# City of San Antonio

Re: Sinclair Tract

MDP # 032-06

The City Staff Development Review Committee has reviewed the Sinclair Tract Master Development Plan M.D.P. # 032-06. Please find enclosed a signed copy for your files. Your plan was approved for acceptance; however please note the following conditions:

MASTER DEVELOPMENT PLAN  
SINCLAIR TRACT

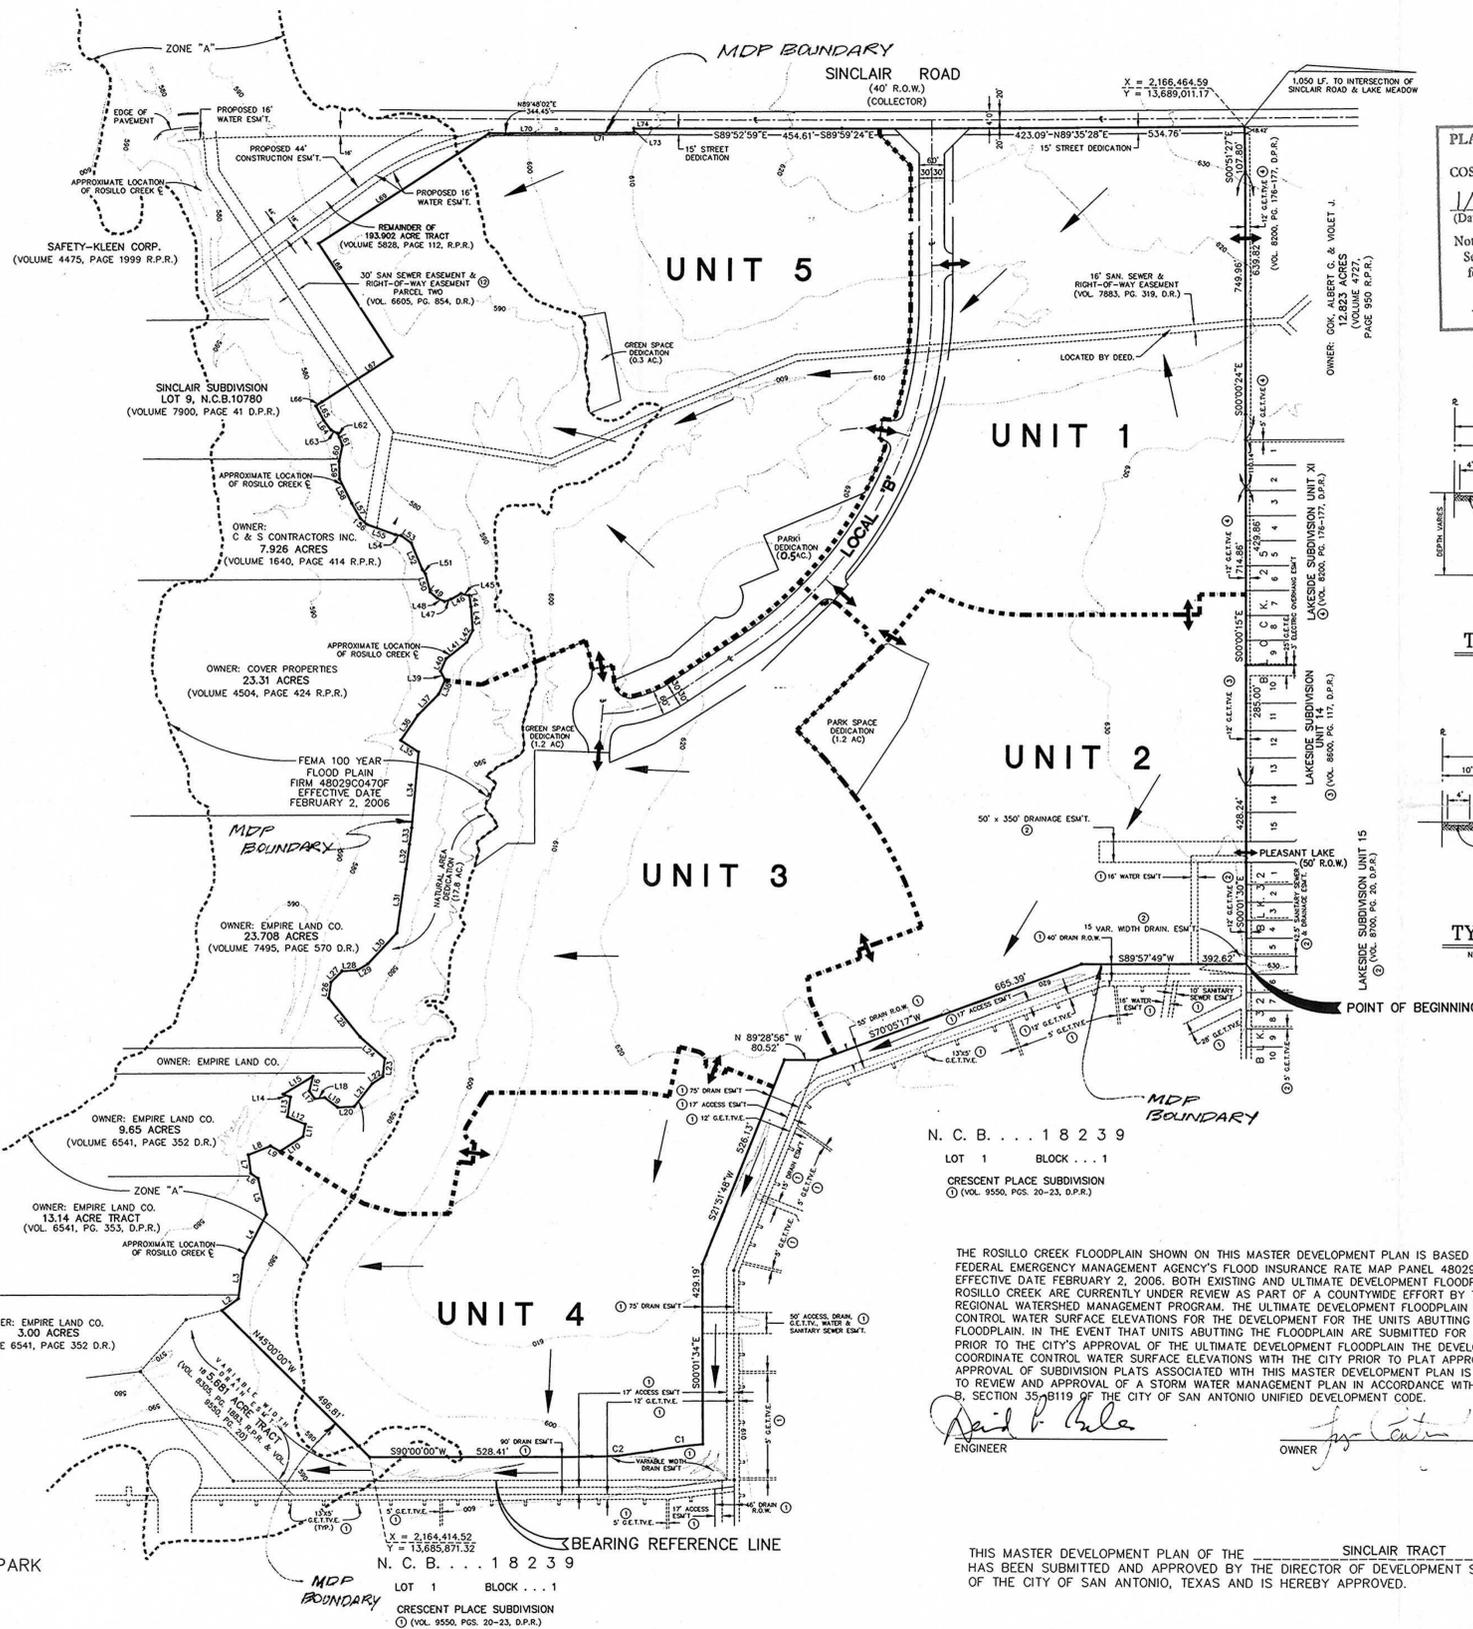
In consideration of public safety and convenience, excessive grades by reason of topography should be avoided in street layouts and arrangements. Any access and R.O.W. issues along state facilities will need to be resolved with the **Texas Department of Transportation (TXDOT)**. For information about these requirements you can contact TXDOT at 615-5814.

**DSD – Traffic Impact Analysis & Streets** indicate that under the UDC listed below are some of the requirements and onsite improvements that are necessary and shall be provided by the developer, on and before the completion of the Sinclair Tract MDP, at no cost to the City of San Antonio:

- UDC 35-502 (a) roadways.
- UDC 35-506 (q) sidewalks.
- All access shall provide clear sight distance.
- Left and right turn deceleration lanes will be required at the main entrance at time of platting.

It should be understood that this is a general review of a conceptual plan not an in-depth review of internal and external traffic flow, or streets and drainage plans. The internal street network shall be planned in order to provide safe and efficient movement of traffic to and from, within and past, the proposed development, while minimizing the impact to non-site trips. All technical requirements of the Unified Development Code will be complied with at the time of platting

**Parks and Recreation** recommends approval with the following conditions:

- The parkland provided shall be shown as “Park” or “Open Space” on a plat; UDC section 35-503(e) *Designation of Parkland*.
- The parkland provided is dedicated to the Homeowners Association.
- The instruments creating the Homeowners Association are provided by the second application for plat approval; UDC section 35-503(e) *Designation of Parkland*.
- Parkland dedication, including open play area, shall be platted by the second phase of residential development; UDC section 35-503 (f) *Development Phasing*.
- All amenities provided shall comply with standards and specifications found in UDC section 35-503(h) *Credit Park Facilities* and Table 503-4 if any credit is to be awarded.

**Historic** states the following:

- The Texas Sites Atlas indicates that no archaeological sites have been previously identified within the above referenced property. However, the project area is adjacent to Rosillo Creek and there is a **high probability** that the property may contain sites, some of which may be significant. In particular, the project area is within possible proximity of the **Battle of Rosillo Creek fought in 1813**. Thus, before any work that might affect any sites is begun, a qualified professional should conduct an archaeological investigation of the property.

The property must be platted in accordance to the UDC and the Major Thoroughfare Plan to reflect the approved MDP. It is suggested to work closely with the school district, so they can plan accordingly.
